Access Compliance Report Public Rights-of-Way (Curb Ramps)

Intersection ID: 12164 Main Street: SEIGLE_AV Cross Street: BELMONT_AV Location: E

ADA ID: 3B644A82A102 Ramp Type: Perp Initial Pass/Fail: Fail Overall Compliance: No Severity Score: 13.75

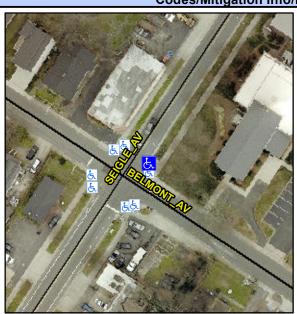
PROW/ADA:
R304.2.2

Fleid Measurements/Component Compilance					
Compliance Description		Data	Compliance Description		Data
N/A	Ramp Length (in)	78.0	No	Ramp Slope (%)	9.6
Yes	Ramp Width (in)	48.0	Yes	Ramp XSlope (%)	3.7
N/A	Flare Type LT	N/A	N/A	Flare Type RT	N/A
N/A	Flare Slope LT (%)	N/A	N/A	Flare Slope RT (%)	N/A
N/A	Flare Traversable LT?	N/A	N/A	Flare Traversable RT?	N/A
N/A	Landing Length (in)	N/A	N/A	DWS Provided?	N/A
N/A	Landing Width (in)	N/A	N/A	DWS Contrast?	N/A
N/A	Landing Slope (%)	N/A	N/A	DWS Length (in)	N/A
N/A	Landing X Slope (%)	N/A	N/A	DWS Full Width?	N/A
N/A	Landing Curb? (Y/N)	N/A	N/A	DWS Offset (in)	N/A
N/A	Shared Landing?	N/A			
N/A	Gutter Ponding?	N/A	N/A	Gutter Slope (%)	N/A
N/A	Gutter Lip Ht (in)	0.5	N/A	Gutter X Slope (%)	N/A
N/A	Painted X Walk1?	No	N/A	Painted X Walk2?	N/A
	X Walk 1 Direction	To NW		X Walk 2 Direction	N/A
N/A	X Walk 1 Width (in)	N/A	N/A	X Walk 2 Width (in)	N/A
	X Walk 1 Slope (%)	2.7		X Walk 2 Slope (%)	N/A

Remove & Replace Entire Ramp.
